No. AS365-71.00.28

ALERT SERVICE BULLETIN

POWER PLANT - Firewall

Modification of the material of the firewall edging

Figure 1

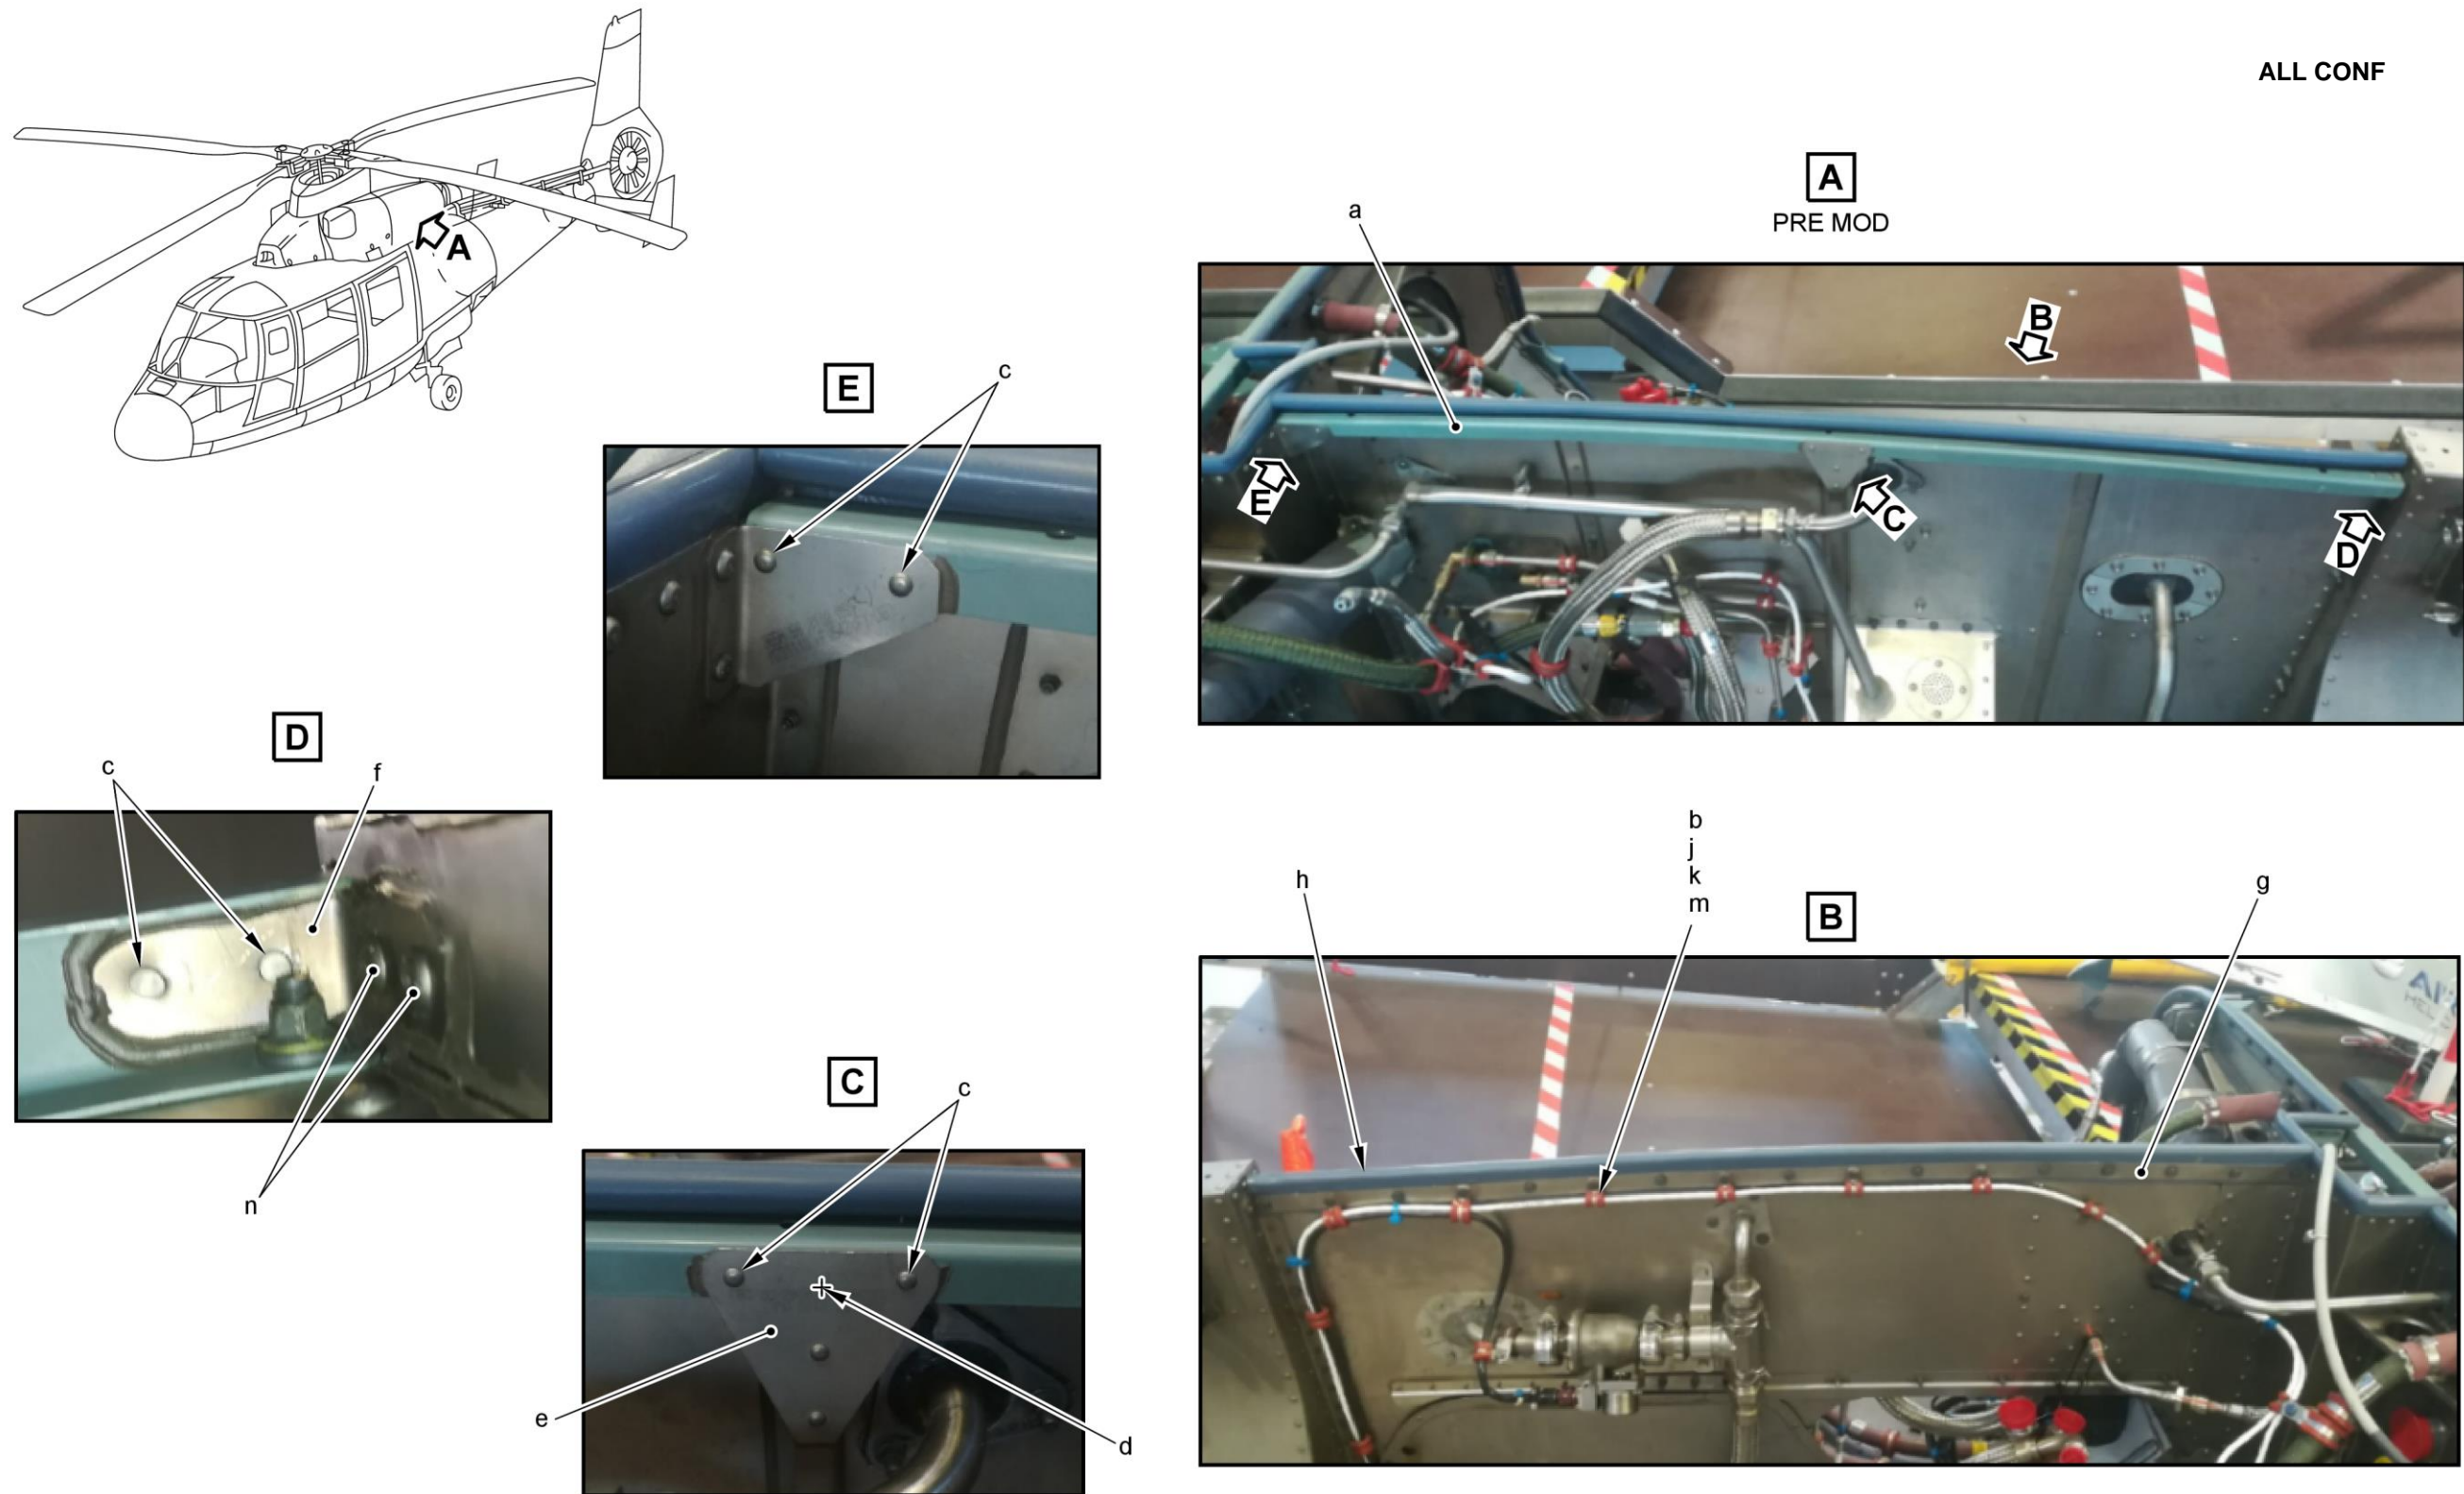
3.B.2.a. Removal of the aluminum stiffener from the firewall ([Figure 1](#))

- Remove the rivets (c) from the stiffener (a). Refer to Work Card 20-03-01-102 (MTC).
- If the center rivet (d) is installed on the gusset (e) (DETAIL C):
 - . Remove the rivet (d). Refer to Work Card 20-03-01-102 (MTC).
- Remove and discard (DETAIL B):
 - . The stiffener (a)
 - . The bolts (b)
 - . The washers (j)
 - . The nuts (k).
- Remove and keep (DETAIL A and DETAIL B):
 - . The cover strip (g)
 - . The fireproof seal (h)
 - . The clamps (m).
- If the bracket (f) is in unsatisfactory condition (DETAIL D):
 - . Remove the rivet (n)
 - . Remove and discard the bracket (f).

Figure 2

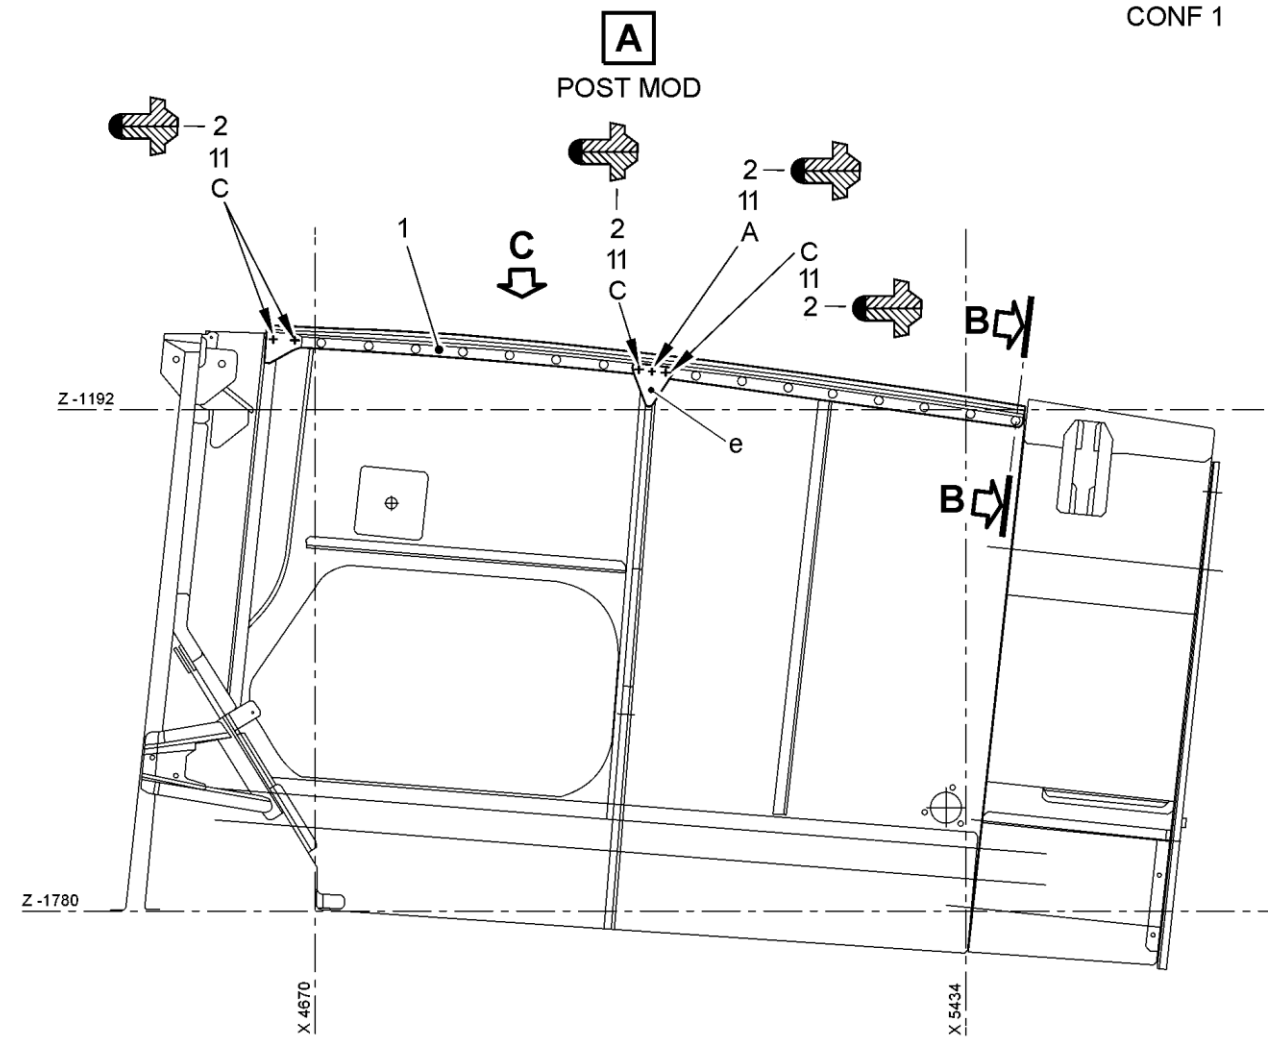
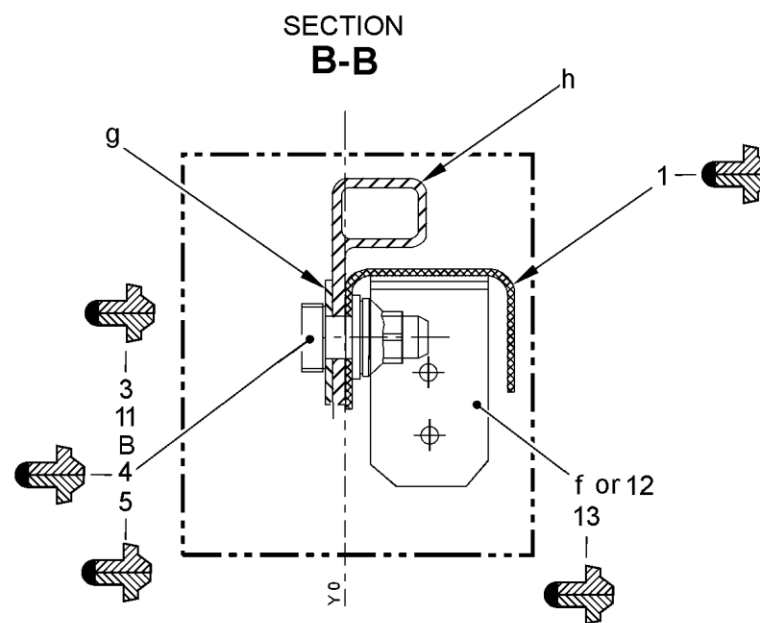
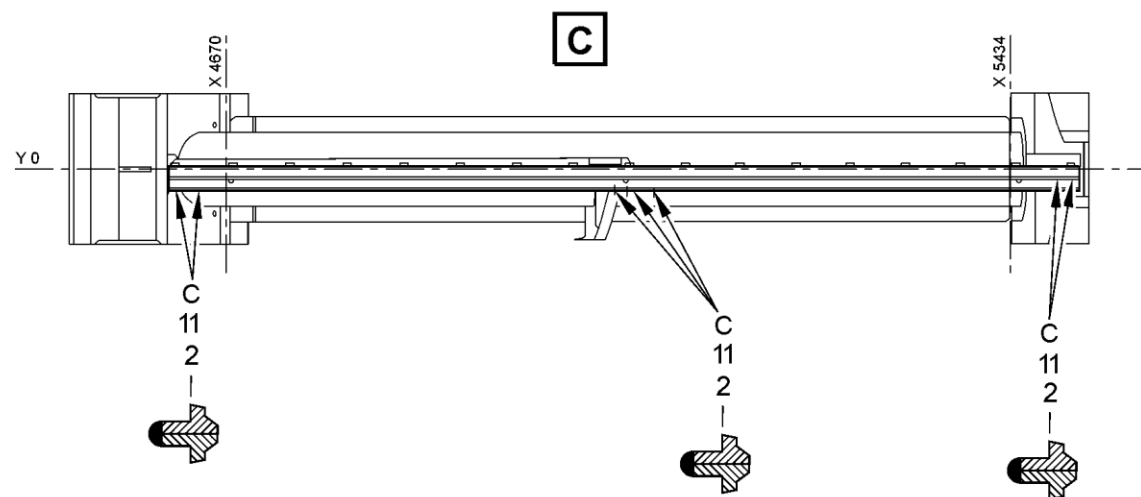
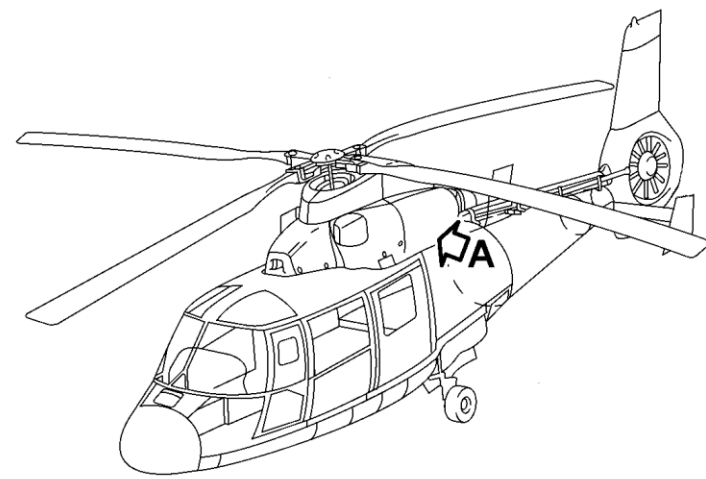
- Modify the Figure 2 (removal of the washer under the head of bolt (3) in the SECTION B-B)
- Modify the Figure 3 (SECTION B-B instead of SECTION C-C)
- Update paragraph 1.L. because the Illustrated Part Catalog (IPC) is up to date with the modification.

CONF 1 ([Figure 2](#))

- Put in position the stiffener (1) on the firewall to agree with the existing holes.
- If there is a hole (A) on the gusset (e) (DETAIL A):
 - . Counter-drill the hole (A) to 2.4 mm diameter on the stiffener (1).

- Counterdrill the holes (B) to 5,5 mm diameter to agree with the existing firewall holes.
- Counterdrill the holes (C) to 2,4 mm diameter to agree with the existing firewall holes.

- Deburr and apply protection with interposition sealant (11) to the holes (A), (B) and (C). Refer to Work Card 20-05-01-227 (MTC).
- If the bracket (f) is removed:

- . Replace it with a new bracket (12) (SECTION B-B). Refer to paragraph [2.C](#).
 - . Install the new bracket (12) on the firewall with rivets (13).
- Install all the rivets (2) on the stiffener (1), the gusset (e) and the bracket (12) or (f) with the sealing compound (14) (DETAIL A and DETAIL C). Refer to Work Card 20-03-02-406 (MTC) and Work Card 20-05-01-222 (MTC).

- Do a check of the cover strip (g) and the fireproof seal (h) to replace if necessary (SECTION B-B). Refer to Work Card 71-30-10-702 (MRM).
- Install the stiffener (1), the cover strip (g) and the fireproof seal (h) (DETAIL A, DETAIL C and SECTION B-B) with:

- . The bolts (3)
 - . The washers (4)
 - . The nuts (5)
 - . The clamps (m) (not shown)
 - . The sealing compound (14). Refer to Work Card 20-05-01-222 (MTC).

Figure 3

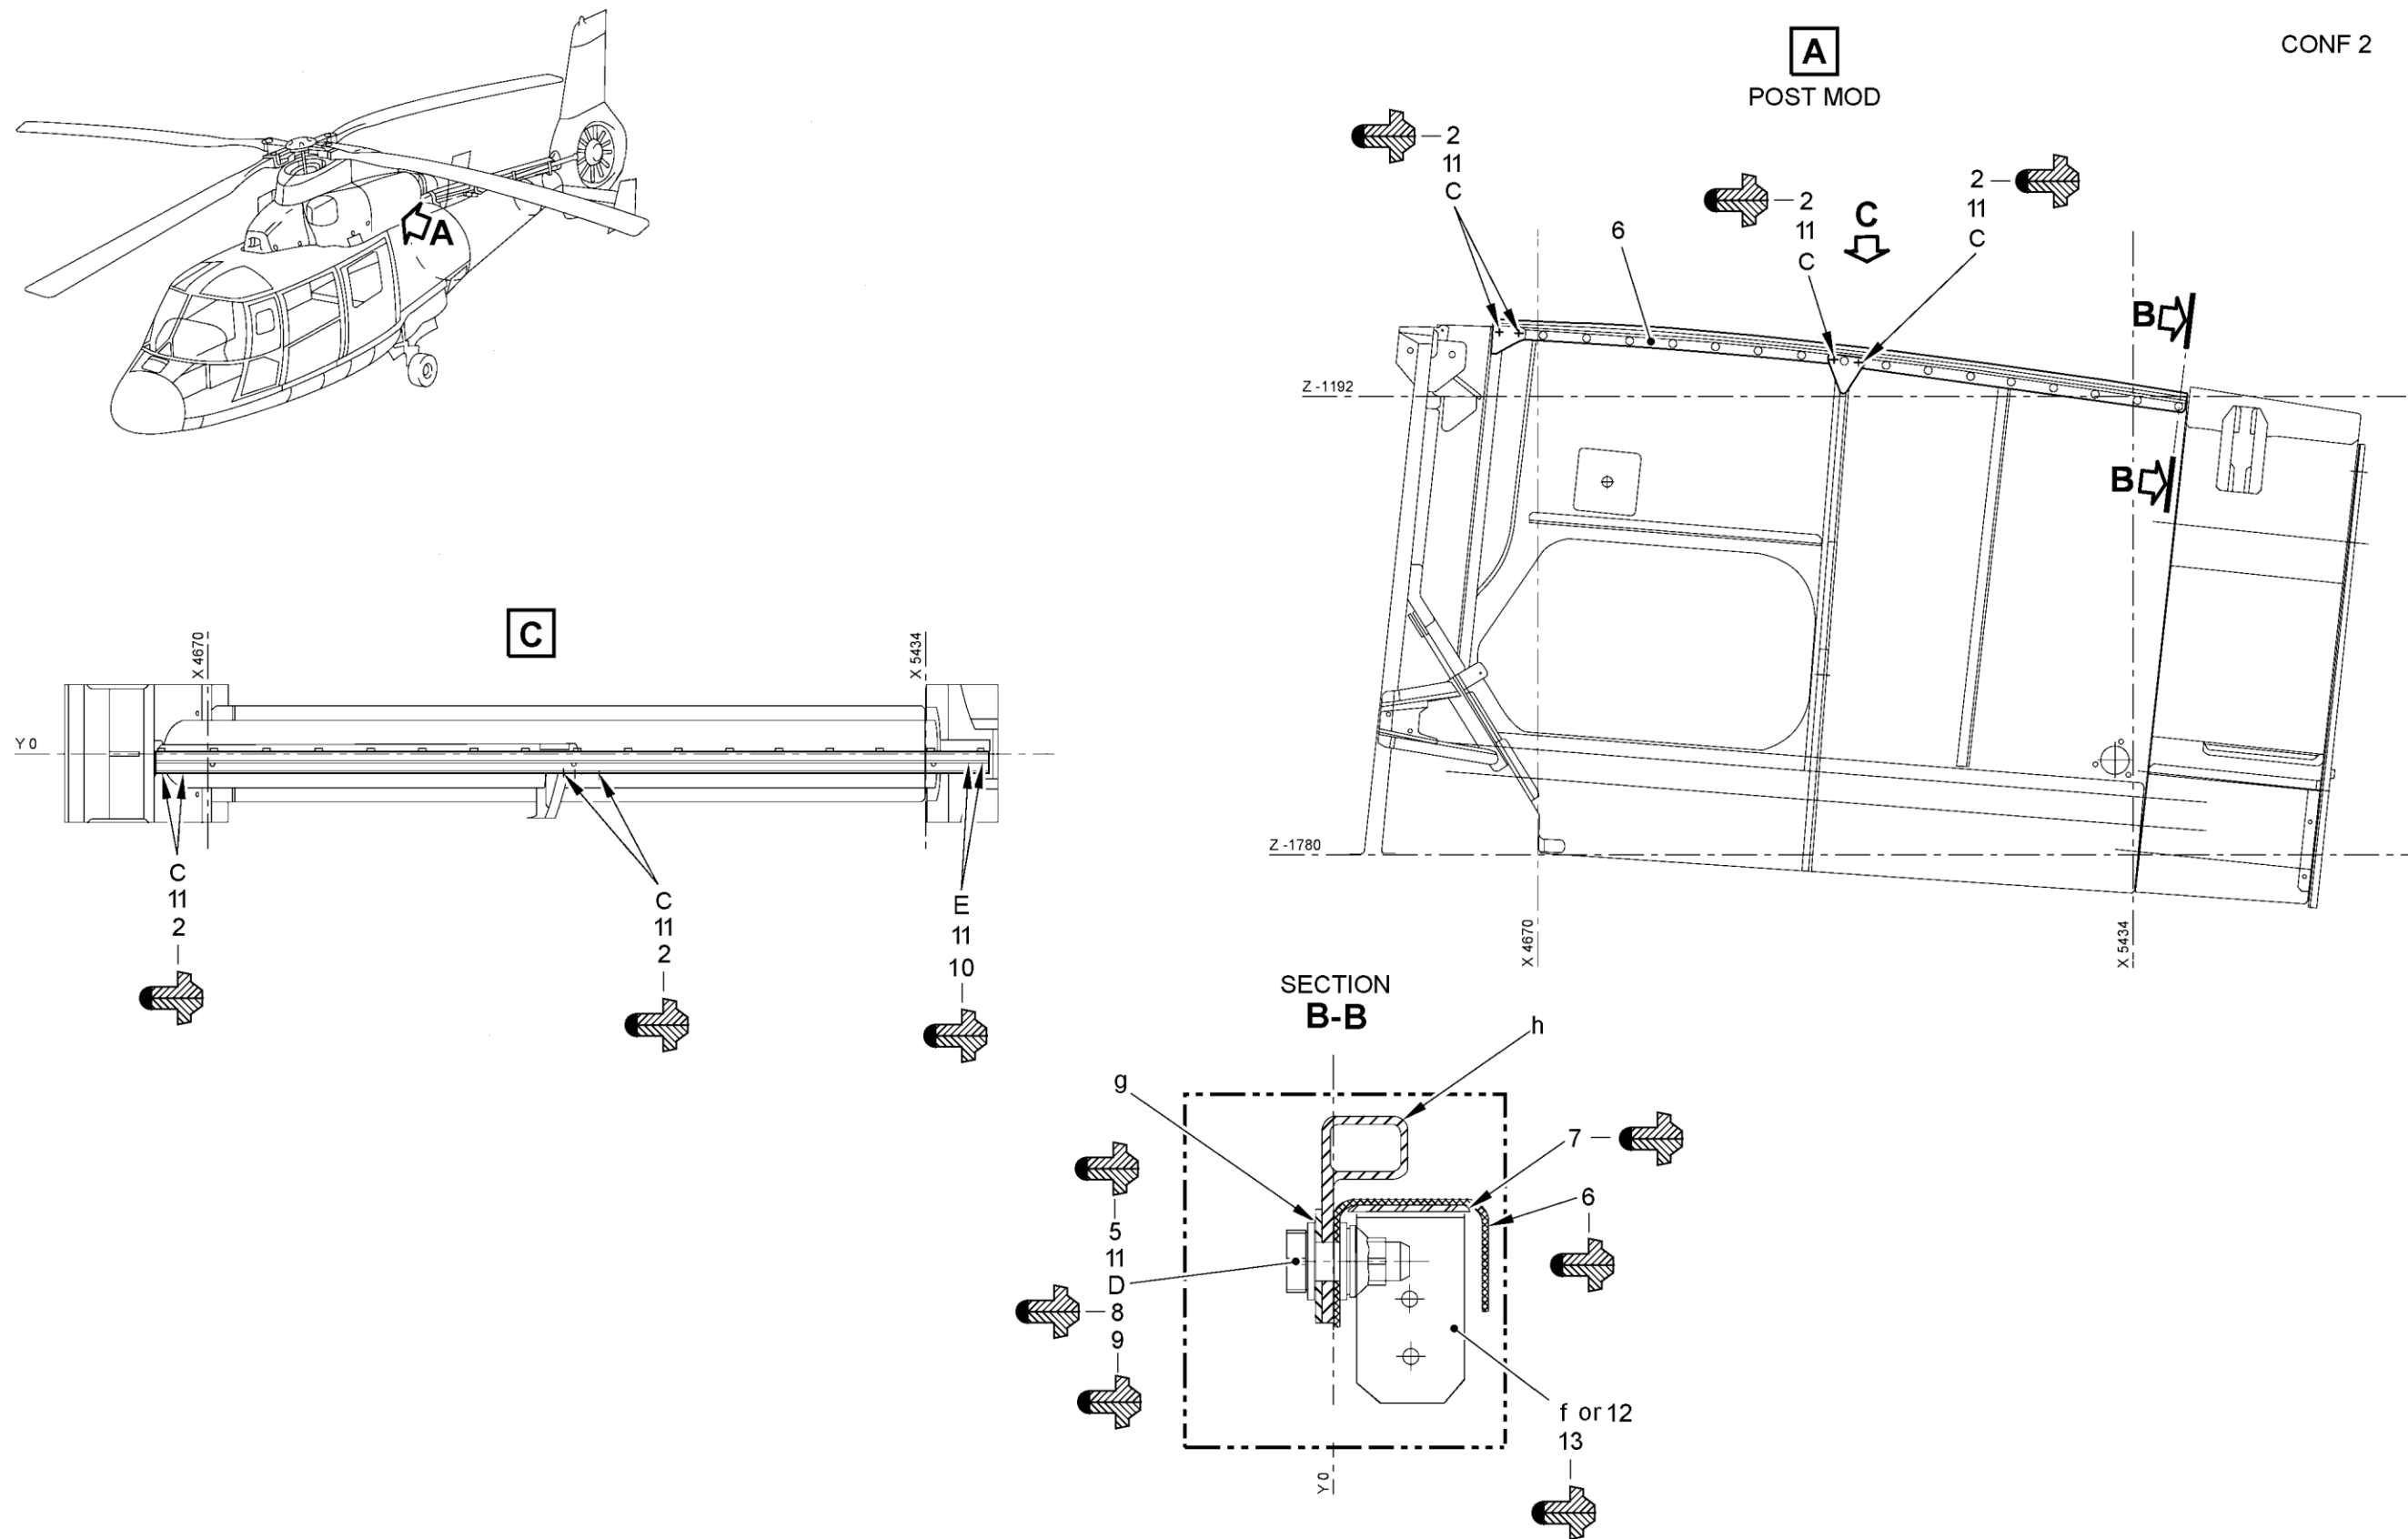
CONF 2 (Figure 3)

- Put in position the stiffener (6) on the firewall to agree with the existing holes (DETAIL A, DETAIL C, and SECTION B-B).
- Counterdrill the holes (C) to 2,4 mm diameter to agree with the firewall.

- Counterdrill the holes (D) to 5,5 mm diameter to agree with the firewall.
- Counterdrill the holes (E) to 2,4 mm diameter to agree with the firewall.
- Deburr and apply protection with interposition sealant (11) to the holes (C), (D) and (E). Refer to Work Card 20-05-01-227 (MTC).

- If the bracket (f) is removed:
 - . Replace it with a new bracket (12) (SECTION B-B). Refer to paragraph [2.C](#).
 - . Install the new bracket (12) on the firewall with rivets (13).

- Install all the rivets (2) and (10) on the stiffener (6), the shim (7), the gusset (e) and the bracket (12) or (f) with the sealing compound (14) (DETAIL A and DETAIL C, SECTION B-B). Refer to Work Card 20-03-02-406 (MTC) and Work Card 20-05-01-222 (MTC).

- Do a check of the cover strip (g) and the fireproof seal (h) to replace if necessary (SECTION B-B). Refer to Work Card 71-30-10-702 (MRM).
- Install the stiffener (6), the cover strip (g) and the fireproof seal (h) (DETAIL A, DETAIL C, and SECTION B-B) with:

- . The bolts (8)
 - . The washers (9)
 - . The nuts (5)
 - . The clamps (m) (not shown).
 - . The sealing compound (14). Refer to Work Card 20-05-01-222 (MTC).
